Access Compliance Report Public Rights-of-Way (Curb Ramps)

Main Street: MARCY_RANCH_RD Cross Street: MARCY_DR Location: NE

ADA ID: RPRK211012173508 Ramp Type: Type 1 - Perpendicular Diagonal Initial Pass/Fail: Fail Overall Compliance: No Severity Score: 16

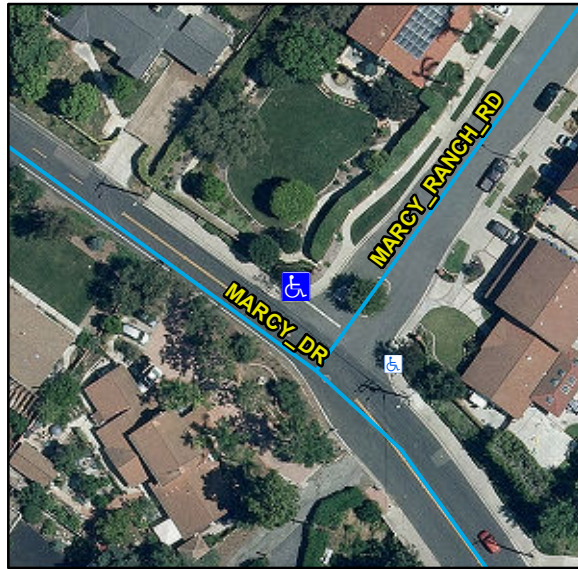
R304.2.2, R204.3, R304.5.3, R302.7.2, STD 1115

Remove & Replace Curb Ramp With Two New Directional Ramps or Equivalent.
